# Memo

Subject: Astoria Development (3771, 3783, 3793 Howard Avenue), Windsor  
Offset Driveway Review

**SPC1.0**

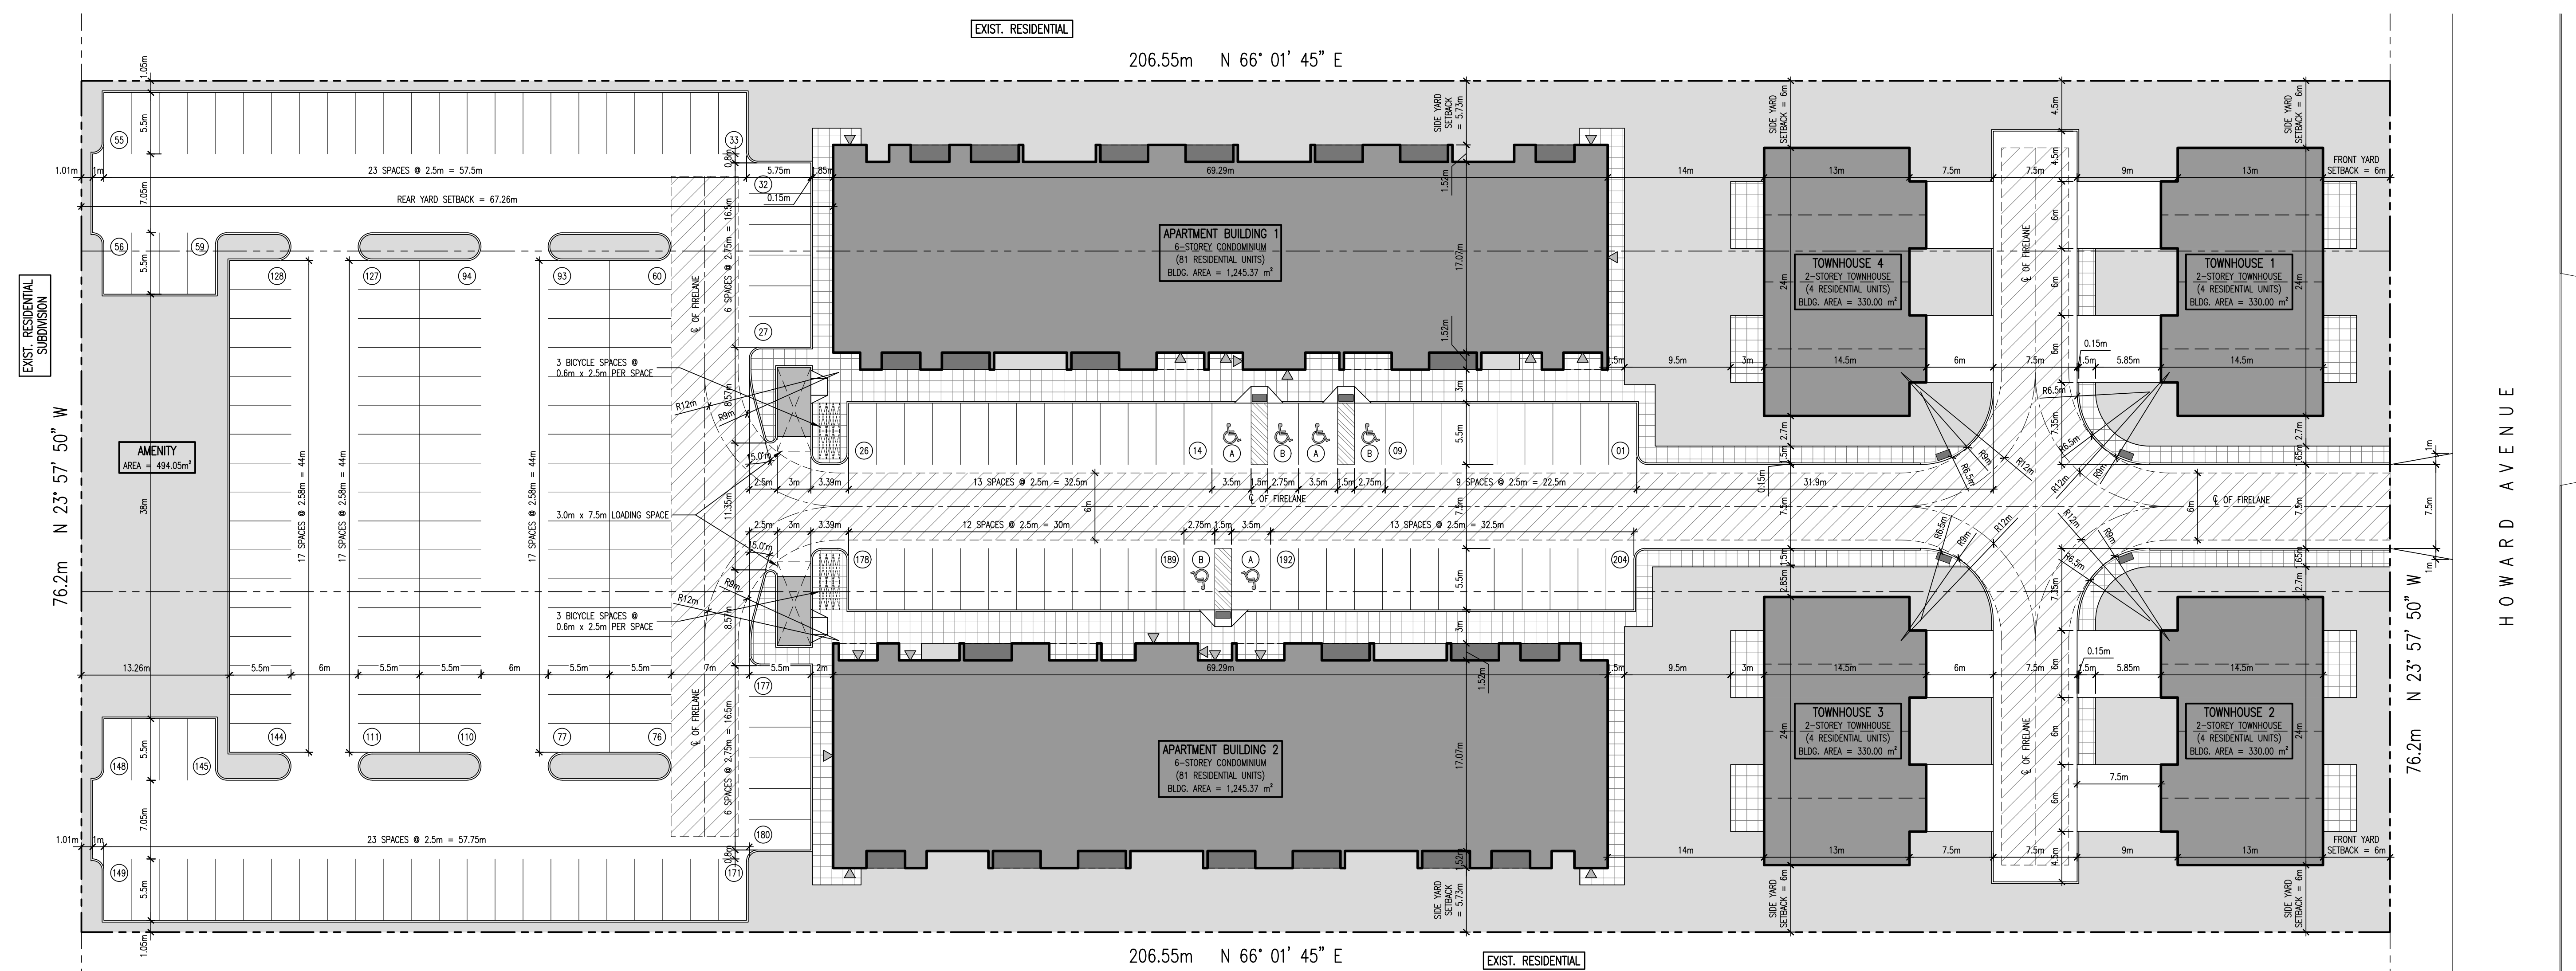
On October 17, 2025 a meeting was held with City transportation staff to discuss the proposed driveway location. At that meeting, City staff requested that the proposed site driveway be aligned with the Lily Mac Boulevard intersection with Howard Avenue; essentially creating the fourth leg to this intersection. Dillon indicated that the width of Lily Mac Boulevard is approximately 18 metres wide (due to a large centre median island, which is approximately 10 metres wide). As such, to align the site driveway lanes with the Lily Mac Boulevard lanes, would require a site driveway for the Astoria development that is also 18 metres wide. City staff confirmed during that meeting that the City cannot issue a permit for a site

As discussed at the meeting with City staff on March 31, 2026, Dillon acknowledges that the City wishes to have the proposed driveway aligned with Lily Mac Boulevard. However, as per the discussions with City staff on October 17, 2025, it became apparent that this would not be feasible. As noted above, the width of the pavement on Lily Mac Boulevard is nearly 18 metres, and to align the driveway lanes with the lanes on Lily Mac Boulevard, the driveway would need to also be 18 metres wide. This is not feasible, as City staff confirmed it would not issue a permit for a driveway that is 18 metres wide.

So, it is not possible to align the site driveway with the lanes on Lily Mac Boulevard, meaning that the site driveway will be offset from Lily Mac Boulevard in some way. Offsetting the driveway to the north would create an interlocking left-turn issue on Howard Avenue, whereby northbound left-turns on Howard Avenue at a site driveway would potentially "interlock" with southbound left-turns on Howard Avenue at Lily Mac Boulevard. As a result, the site driveway will need to be offset to the south of Lily Mac Boulevard.

By offsetting the site driveway south of Lily Mac Boulevard, the left-turn movements will not interlock, and as such, the left-turn movements can operate effectively.

The proposed site driveway offset (per the attached site plan) from Lily Mac Boulevard is acceptable due to the fact that:

- The driveway lanes cannot be aligned with Lily Mac Boulevard due to the width of Lily Mac Boulevard itself (which is approximately 18 metres);
- The offset orientation of 8 metres to the south removes any potential for interlocking left-turns on Howard Avenue;
- There is no through traffic (i.e., cross-roadway movements) expected between Lily Mac Boulevard and the proposed site driveway which would result in weaving movements across Howard Avenue; and
- The review of vehicle conflicts indicated that the proposed offset driveway orientation results in fewer conflicts compared to a scenario where the driveway is aligned with Lily Mac Boulevard.
